END OF ADDENDUM NUMBER THREE (3)

CLINTON PARKS - PHASE I
CITY OF CLINTON
TRACEWAY PARKS & KIDS TOWNE PARK

SITE PLAN - TOWNE PARK - BASE BID
CCD PROJECT 23043.10

DRAWING NO. **E-1**
R1

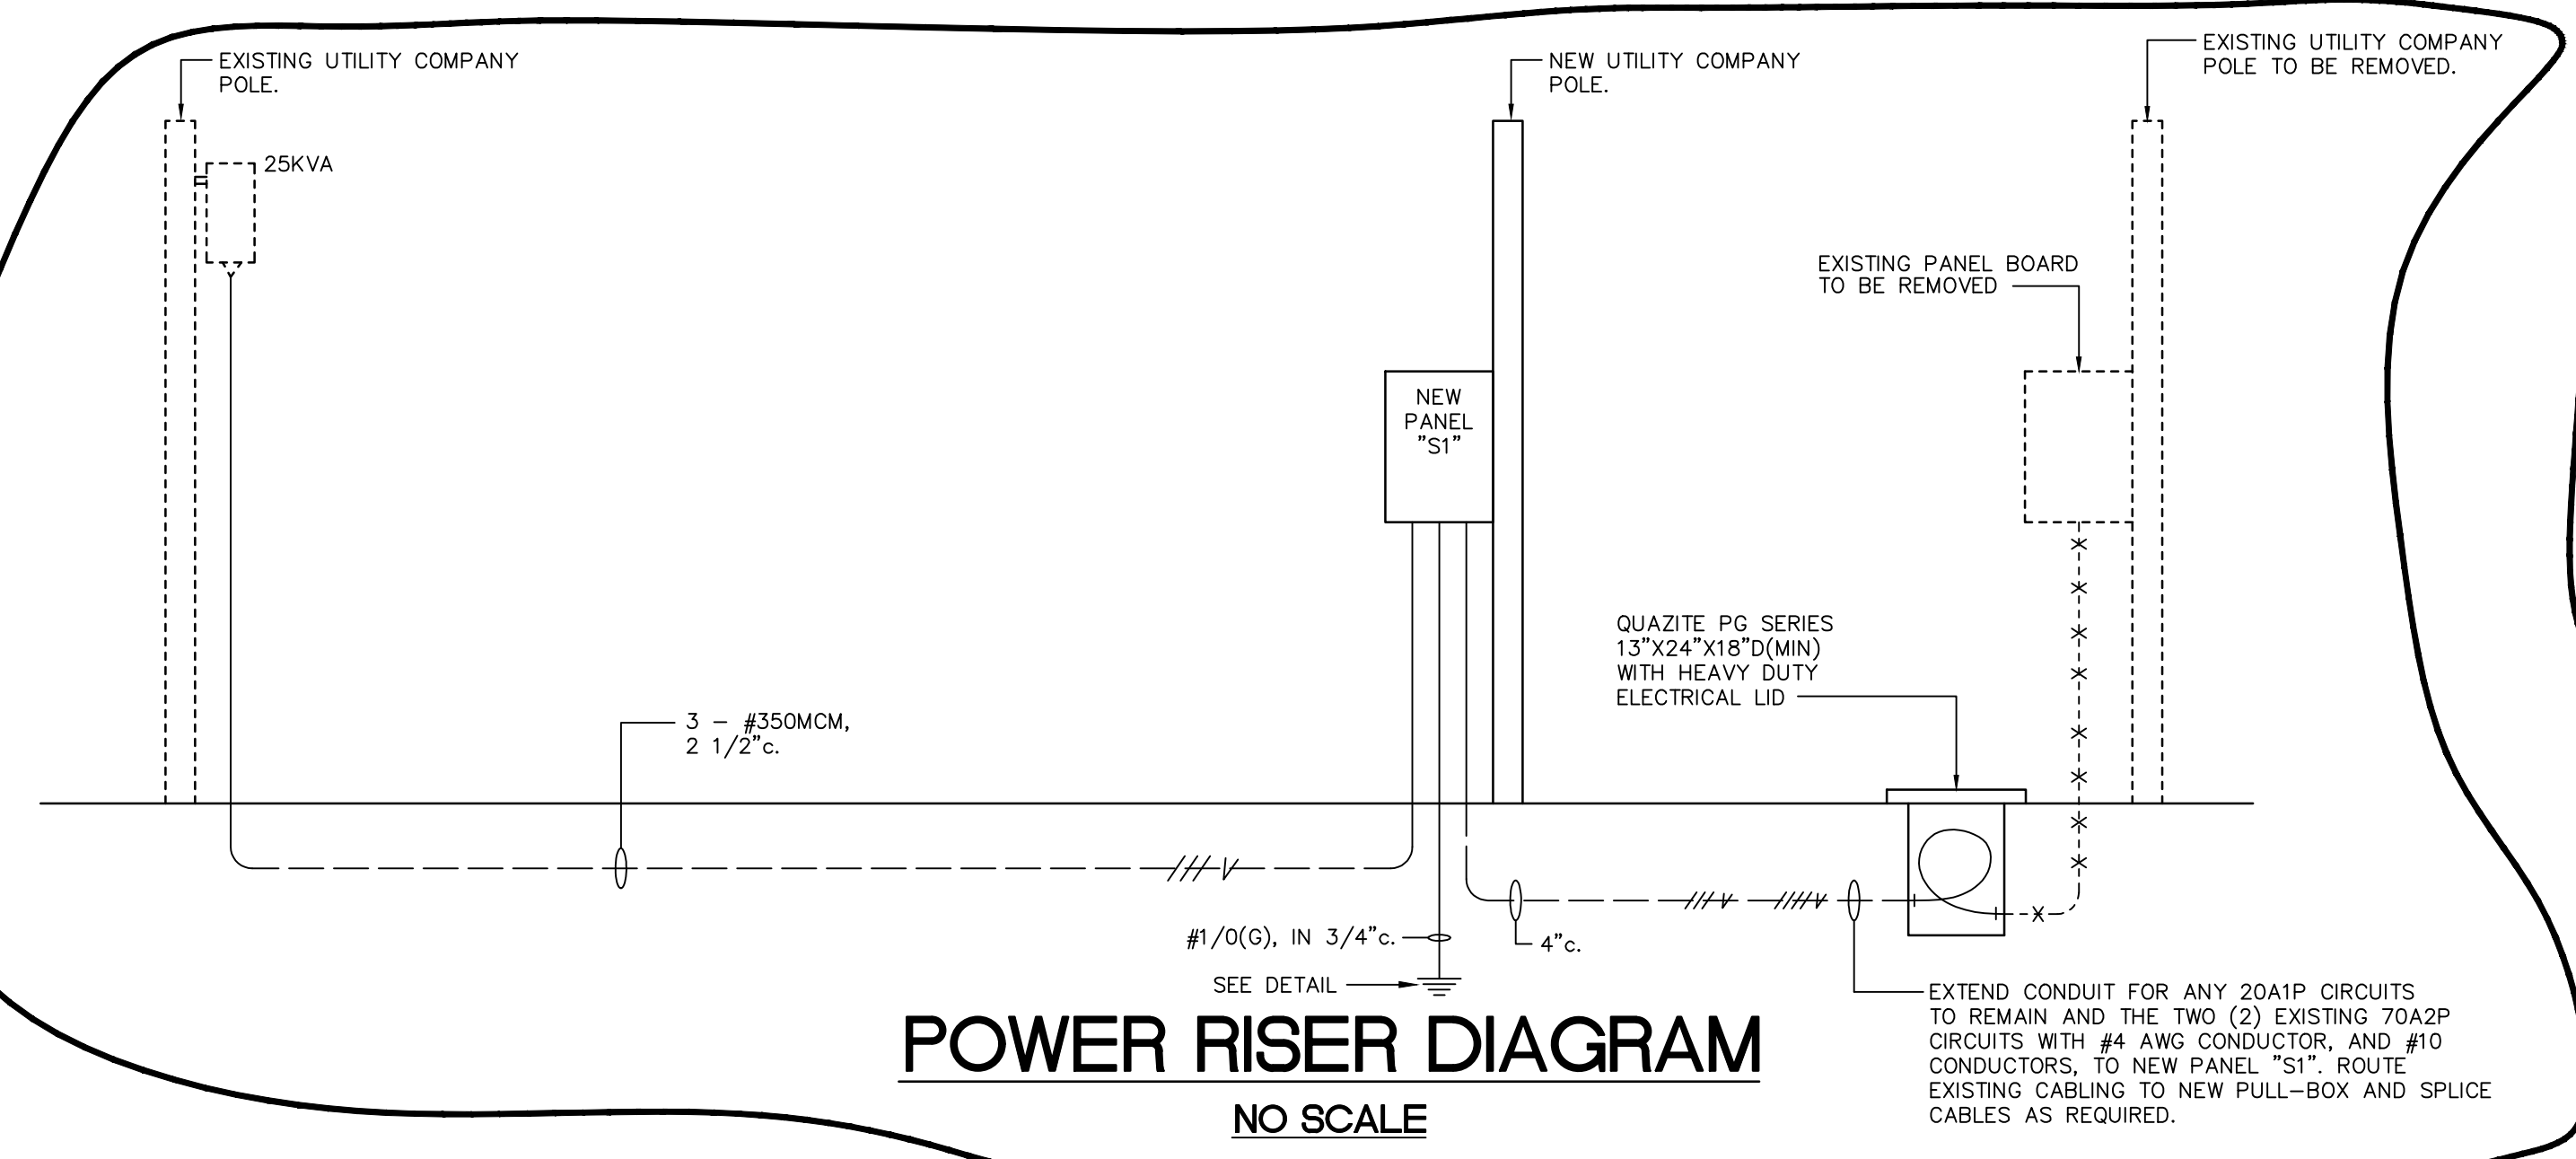
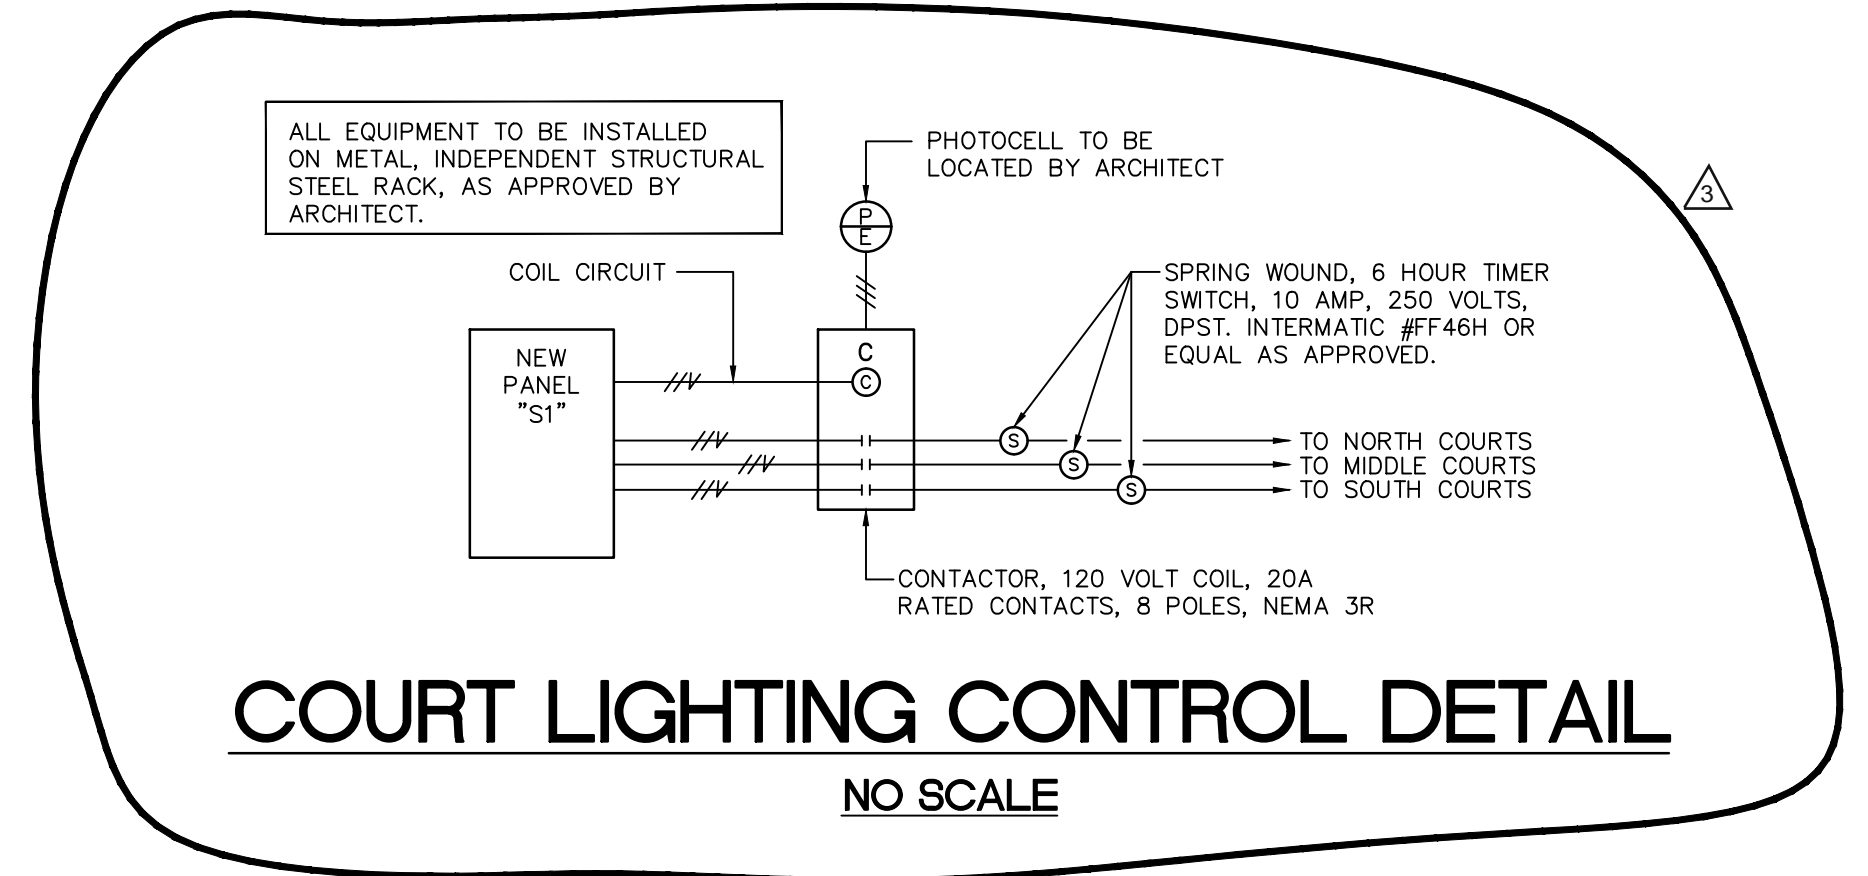
12. **DRAWING E-1, SITE PLAN – TOWNE PARK – BASE BID** – Replace with attached E-1 R1 dated as revised September 5, 2024.
13. **DRAWING E-3, FLOOR PLANS, SCHEDULES, RISER DIAGRAM TOWN PARK ADD ALTERNATE #1; LIGHTING** – Revise as follows:
